KNIGHT CANCER RESEARCH BUILDING

LAND USE REVIEW #1 VS #2 COMPARISON DOCUMENT

LU 15-279775 DZM AD

MAY 02, 2016

FLOORS 6&7 REVISIONS

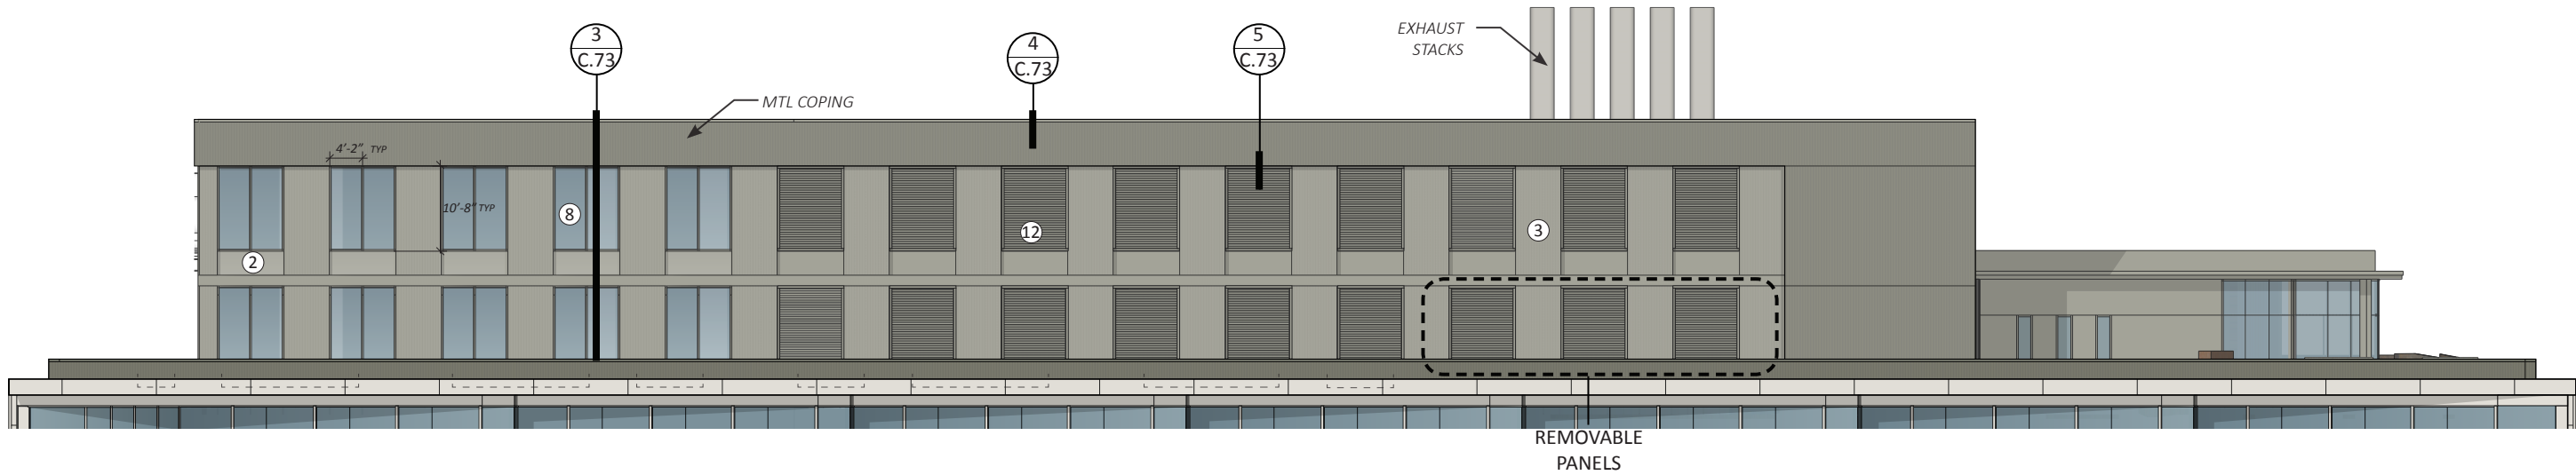
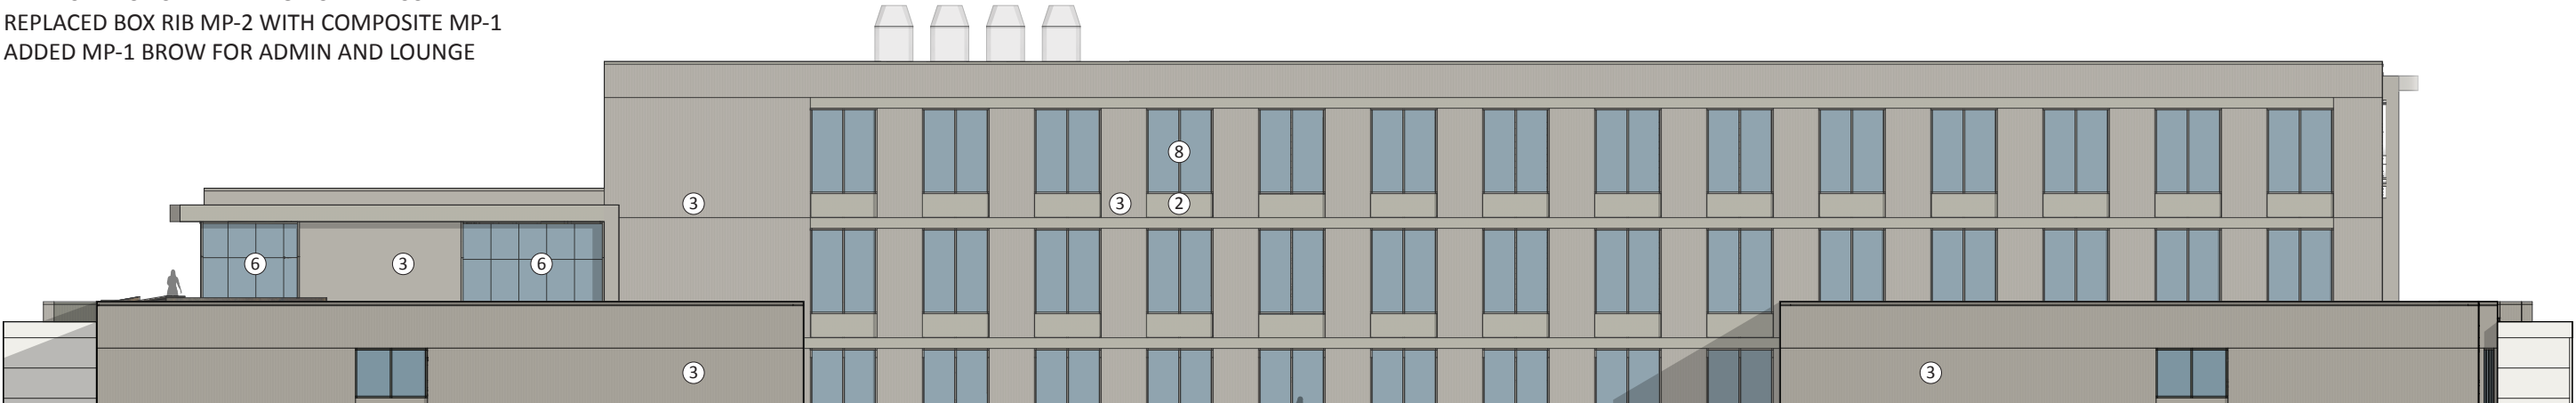
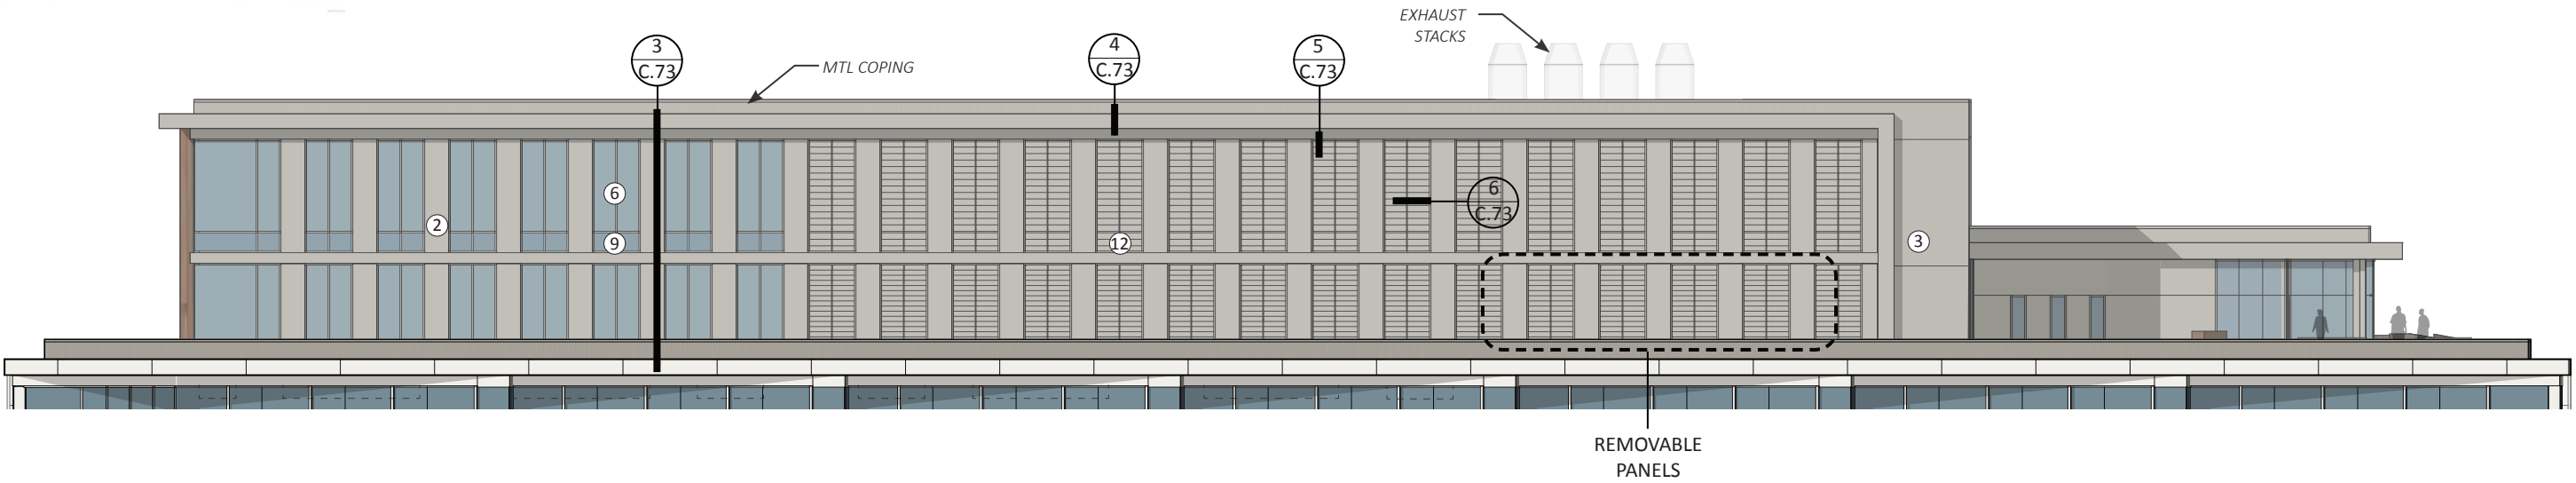
- ELIMINATED DARK METAL PANEL
- INCREASED GLAZING AT ADMIN AREAS
- REPLACED PUNCHED WINDOWS WITH CURTAINWALL
- REPLACED BOX RIB MP-2 WITH COMPOSITE MP-1
- ADDED MP-1 BROW FOR ADMIN AND LOUNGE

MOD 3

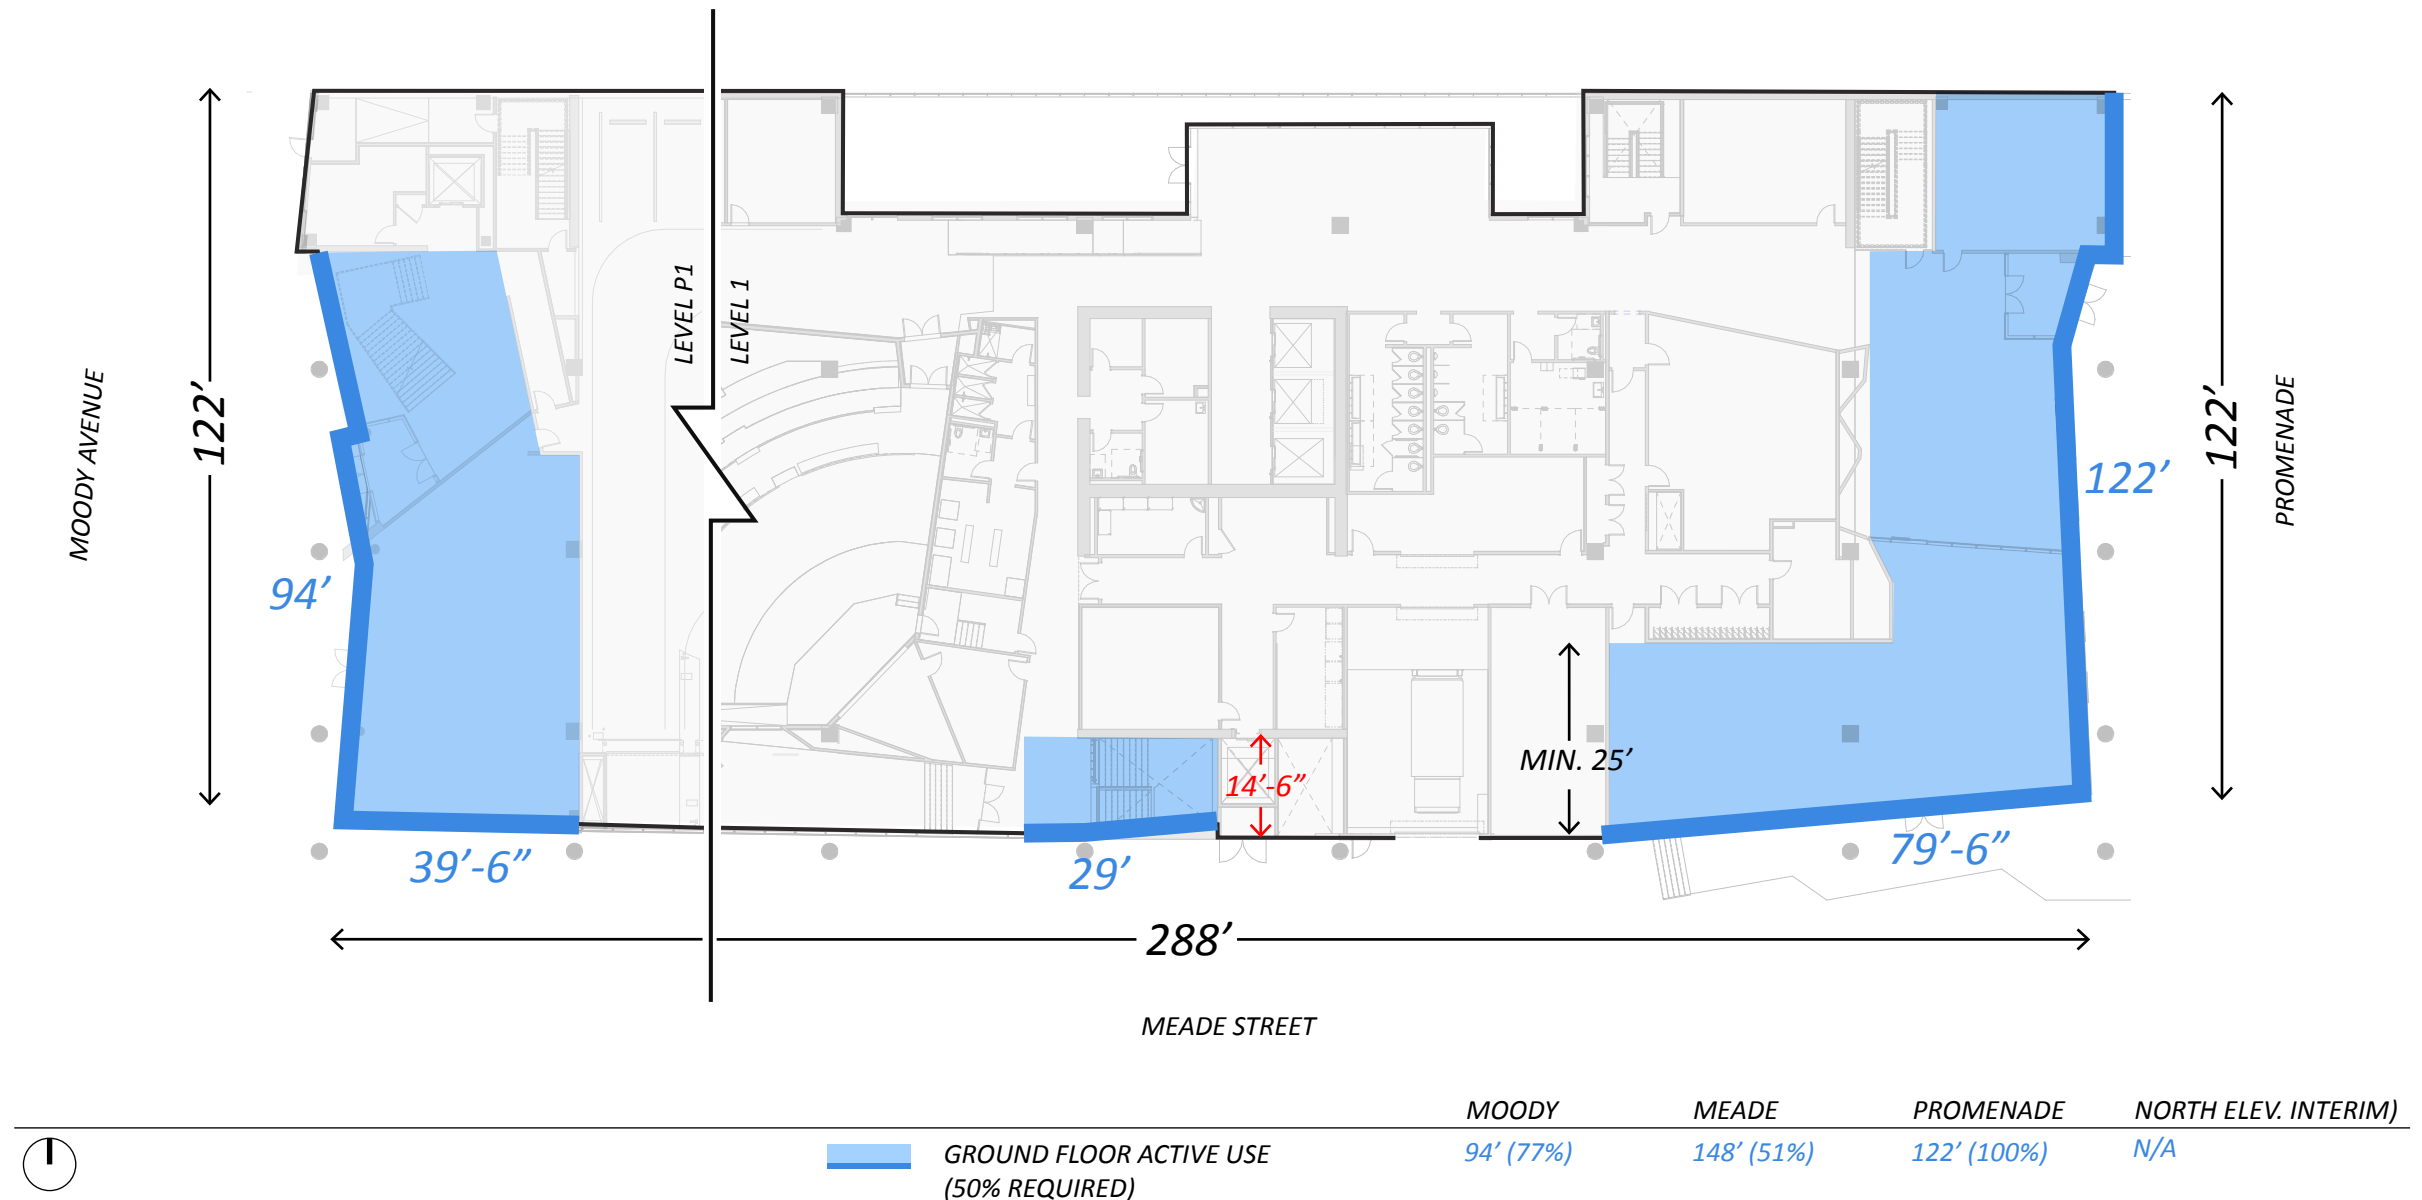
RESPONSE: The mid-block lobby, which has been included in the Active Use calculation, measures 14.5 feet at its shallowest point and does not comply with the required 25 foot depth.

Modification Requested.
